Work Order ID 149933 -1

Item Name: EC135 Bearpaws

DART SERVICE INSTRUCTION
TO AMEND INSTALLATION INSTRUCTIONS IIN-D135-692 REV. B AND
INSTRUCTIONS FOR CONTINUED AIRWORTHINESS ICA-D135-692 REV. 1
REF. FAA STC: SR01042SE
REF. TCCA LETTER OF ACCEPTANCE: 120S-GA-08-52
REF. EASA STC: 10038103

A	NEW ISSUE	ML	18.06.01
REV.	DESCRIPTION	BY	DATE
DESIGN	ML	DART AEROSPACE USA, INC. EUGENE, OR	
DRAWN	ML		
CHECKED	<i>up</i>	DRAWING NO.	REV. A
MFG. APPR.	N/A	DSI 9750	SHEET 1 OF 5
APPROVED	<i>[Signature]</i>	TITLE	SCALE
DE APPR.	<i>[Signature]</i>	INSTALL MODIFICATION	NTS
DATE	16.06.01	COPYRIGHT © 2016 BY DART AEROSPACE USA, INC. THIS DOCUMENT IS PRIVATE AND CONFIDENTIAL AND IS SUPPLIED ON THE EXPRESS CONDITION THAT IT IS NOT TO BE USED FOR ANY PURPOSE OR COPIED OR COMMUNICATED TO ANY OTHER PERSON WITHOUT WRITTEN PERMISSION FROM DART AEROSPACE USA, INC.

FIGURE 1: MODIFICATION OF D135-692-011 INSTALLATION
NOT TO SCALE

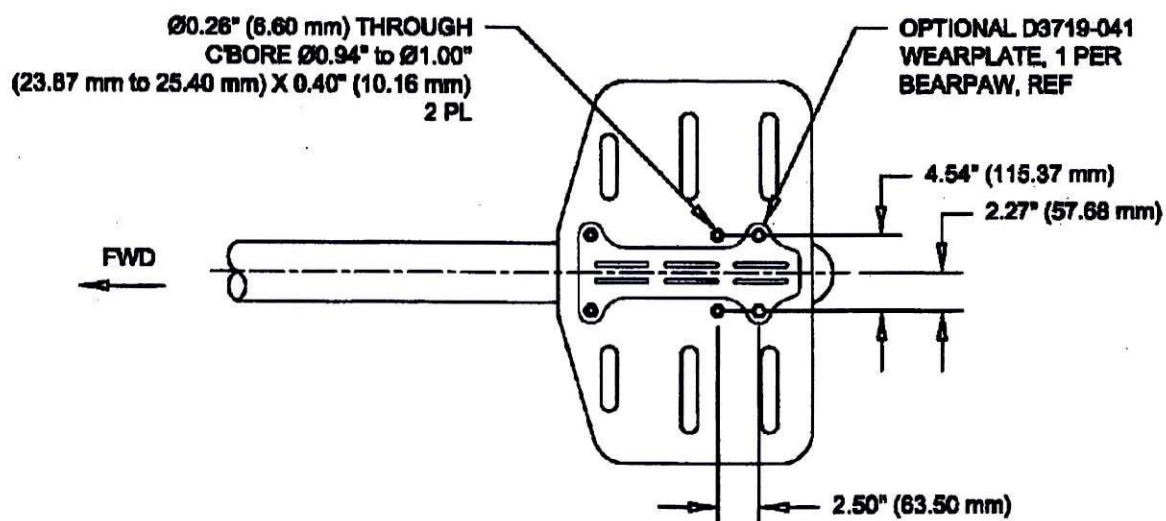
The purpose of this Dart Service Instruction is to allow customers with D135-692-011 Bearpaws at CHG 002 and earlier to modify the D3049-1 Bearpaw to relocate the aft most D2519 Clamp and D2182B060 Rubber Cushion by up to 2.5" (63.5 mm) further forward to avoid interference with the snow ski provisions on the OEM skidtubes. At CHG 003 and later, the D3049-1 Bearpaw is supplied with the provisions to relocate the clamp and cushion.

NOTE: For D135-692-011 Bearpaw Kits at CHG 002 and prior, drill Qty 2x Ø0.26" (6.60 mm) holes through the D3049-1 Bearpaws as indicated in Figure 1 of this Dart Service Instruction. Counter bore the holes on the underside of the bearpaws Ø0.94" to Ø1.00" (23.87 mm to 25.40 mm) and to a depth of 0.40" (10.16 mm).

**FIGURE 2: HARDWARE INSTALLATION AT AFT HOLE LOCATION
(WITH WEARPLATE, NOT TO SCALE)**

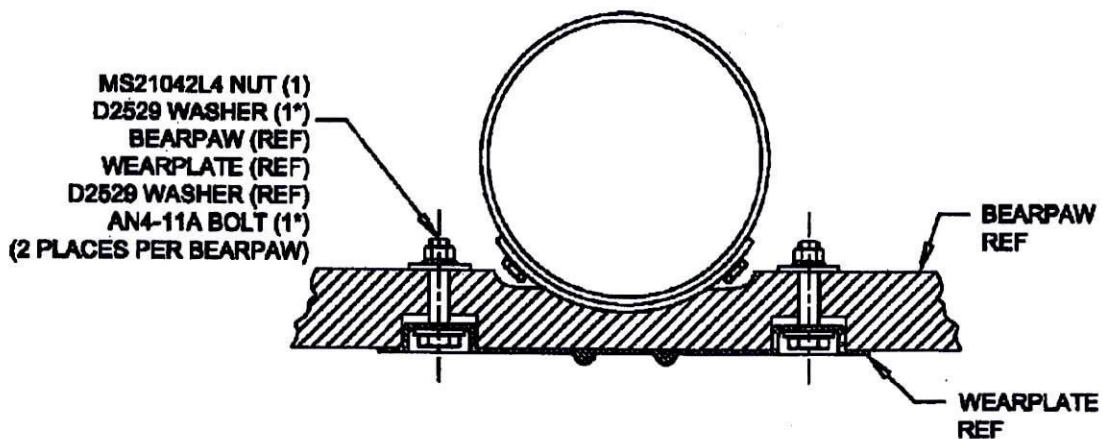
* ADDITIONAL NAS1149D0463J WASHERS MAY BE INSTALLED UNDER THE NUTS TO ENSURE 1.5-4 THREADS IN SAFETY ON THE BOLTS. IT IS ALSO ACCEPTABLE TO REPLACE THE AN4-11A BOLTS WITH LONGER OR SHORTER AN4 BOLTS, IF REQUIRED.

D3049-1 BEARPAW

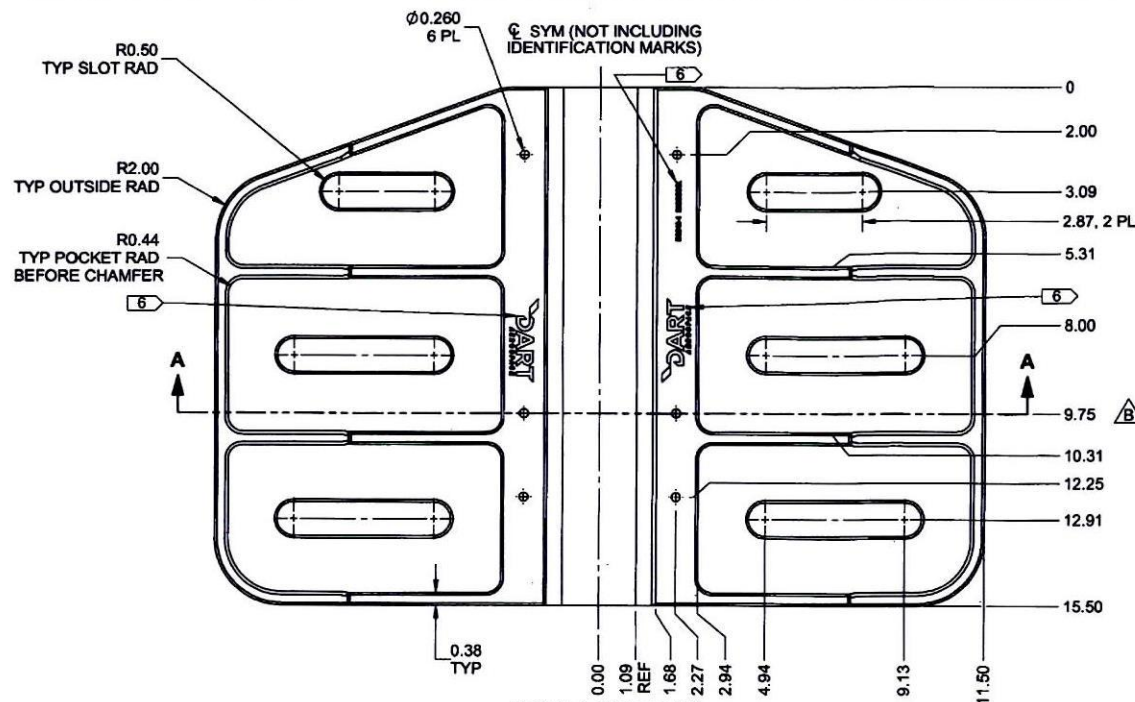
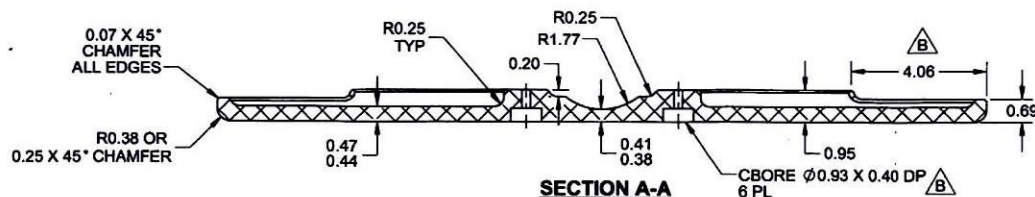
B	REVISE DWG TO CURRENT STANDARDS, ADDED 2 ADDITIONAL CBORE HOLES ZN C6-1, UPDATE DIM'S DUE TO CAD ERROR; Ø0.93 WAS Ø0.75	ML	16.06.01
A	NEW ISSUE	RF	01.10.18
REV.	DESCRIPTION	BY	DATE
DESIGN	ML	DART AEROSPACE USA, INC. EUGENE, OR	
DRAWN	ML		
CHECKED	DB	DRAWING NO.	REV. B
MFG. APPR.	JLM	D3049	SHEET 1 OF 1
APPROVED	HS	TITLE	SCALE
DE APPR.	DS	BEARPAW	NTS
DATE	16.06.01	COPYRIGHT © 2001 BY DART AEROSPACE USA, INC. THIS DOCUMENT IS PRIVATE AND CONFIDENTIAL AND IS SUPPLIED ON THE EXPRESS CONDITION THAT IT IS NOT TO BE USED FOR ANY PURPOSE OR COPIED OR COMMUNICATED TO ANY OTHER PERSON WITHOUT WRITTEN PERMISSION FROM DART AEROSPACE USA, INC.
